### DER Technical Forum – Record of Issues Raised

Figure 1

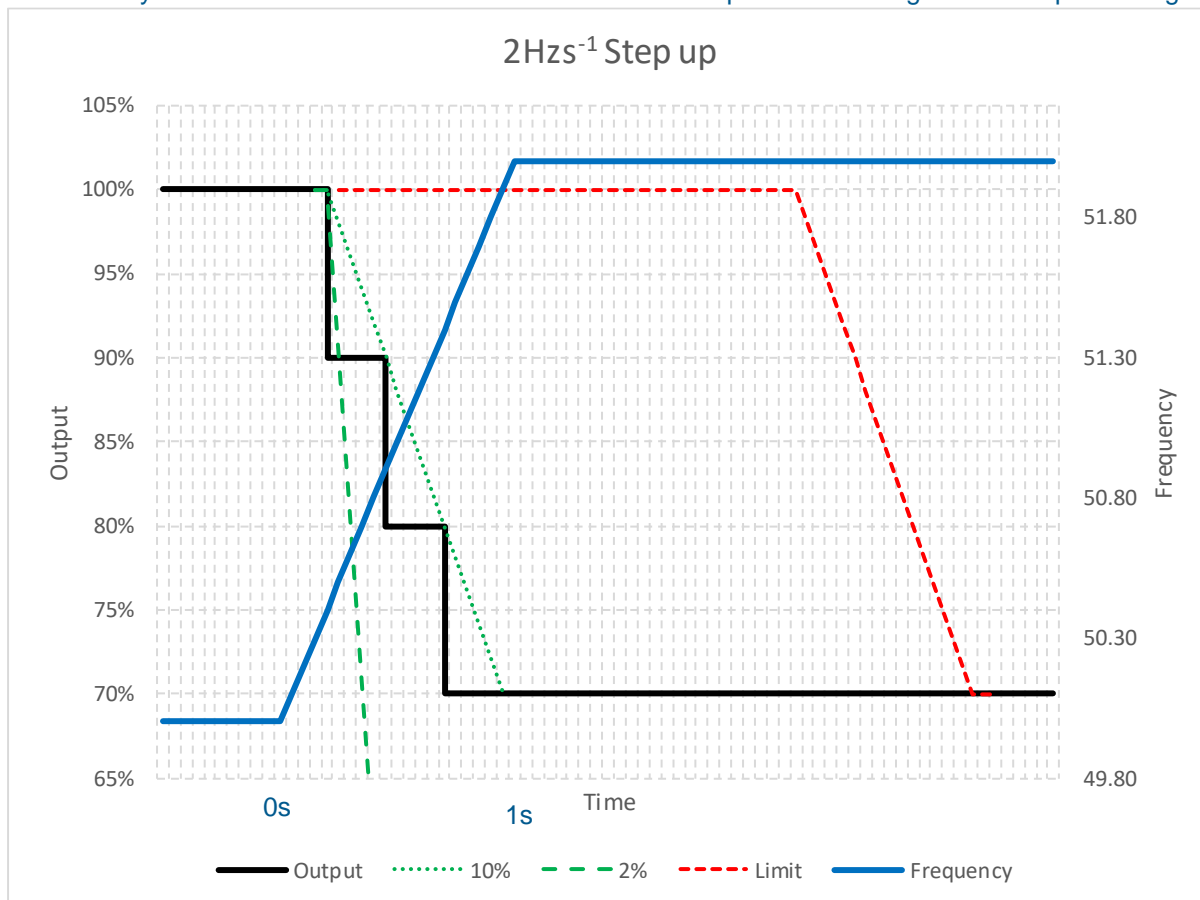
A single frequency response step test (ie no ramp test) is required in Limited Frequency Sensitive Mode (LFSM) to demonstrate the LFSM-O capability in response to a frequency injection of  $2.0 \text{ Hzs}^{-1}$  for 1 s as shown by the figures 1 and 2 below. The test is to be conducted at Registered Capacity (although a lower power output may be agreed with the DNO if site conditions preclude attaining Registered Capacity, such as an absence of adequate water flow rate). Similarly if the frequency step take the operating point below Minimum Stable Operating Level an alternative appropriate injection should be calculated that demonstrates LFSM-O across the range that is available without breaching the Minimum Stable Operating Level.

The frequency input and the expected Active Power response are illustrated below. This should be in accordance with Section 11.2.4 of EREC G99. Undamped oscillations should not occur after the step frequency change.

For both the step up and step down parts of the test the response should commence within 2 s and shall always be to the left of the red line and be as close as possible to the green line representing

Figure 2

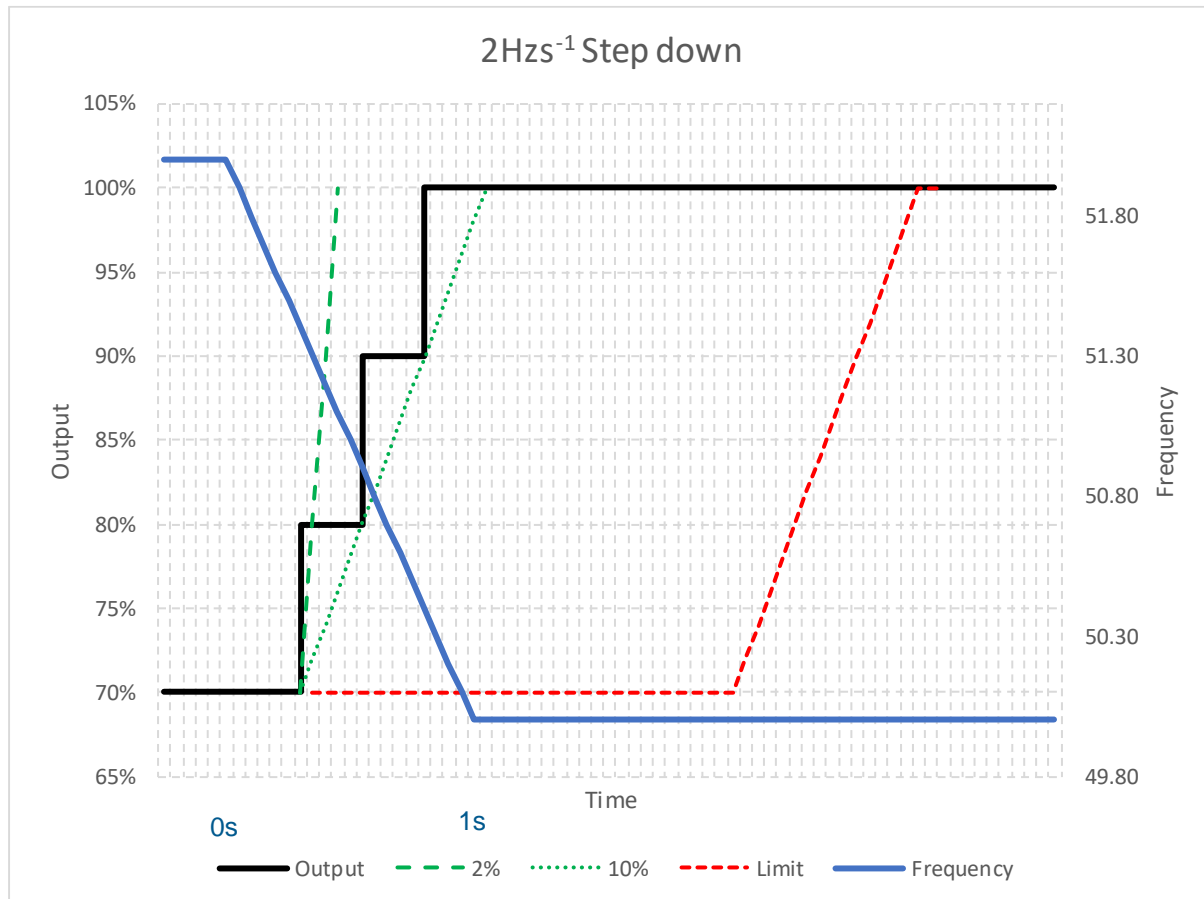
10% droop (unless some other droop is desired by the Generator). It is permissible to be to the left of the 2% droop line when the first load bank is switched in (or the final one switched out, ie the first one to be switched out) but the output must be to the right of the 2% droop line by the time the frequency has reached 52.0 Hz (or returned to 50.0Hz).

### Inverter datasheet:

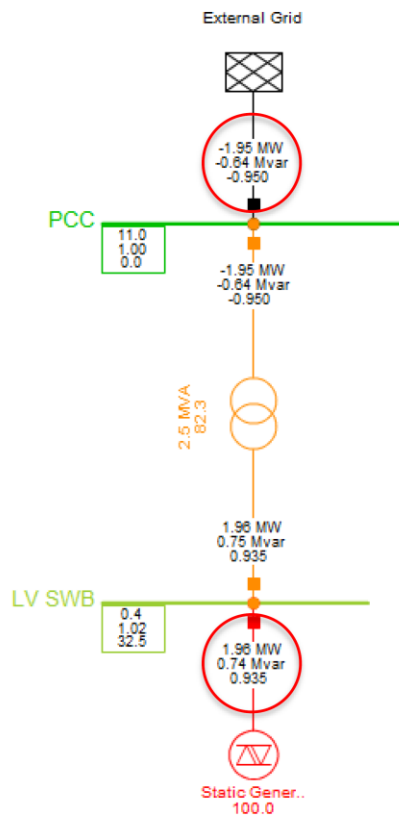
Is the plant compliant with EREC G99 Power Factor Requirements?
